Product Change Notification: CENO-03DKHD890

CCB 7460 Initial Notice: Implement packing material changes for selected PSDS and SIC products available on TO-220, TO-247 and TO-263 packages at FSTS final test site.

### PCN #: CENO-03DKHD890

# Pin Plug Comparison

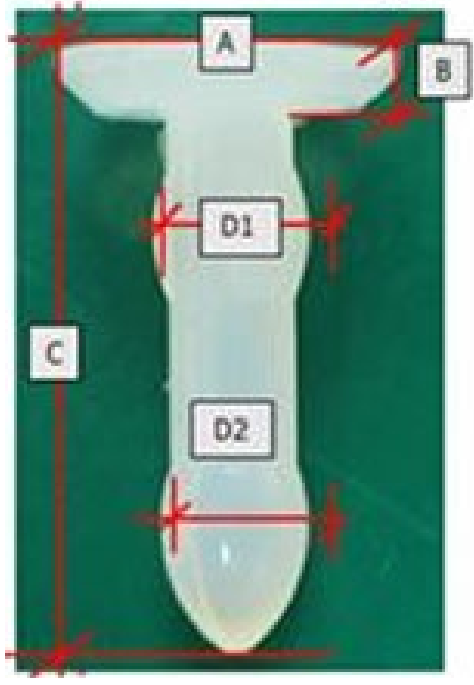
Pre change	Post change
<p><b>Legend:</b>  A – Pin Plug Head Diameter  B – Pin Plug Head Thickness  C – Pin Plug Length  D1 – Top Pin Plug Lock Width  D2 – Bottom Pin Plug Lock Width</p>  <p><i>Black on both sides</i></p>	 <p><i>White @ Pin 1 side and Black @ Opposite side</i></p>

Pin Plug	Material Type	Head design	Head diameter (A)	Head Thickness (B)	Length (C)	Number of Pin lock	Lock location	Top Pin Plug Lock Width (D1)	Bottom Pin Plug Lock Width (D2)	Color
Pre change	PVC	Rounded	5.48 mm	0.90 mm	12.05 mm	1	Bottom	n/a	3.20 mm	BLACK
Post change	Nylon	Rounded	5.50 ± 0.10 mm	1.30 ± 0.10 mm	13.00 ± 0.10 mm	2	Top and Bottom	3.25 ± 0.05 mm	3.25 ± 0.05 mm	BLACK/WHITE
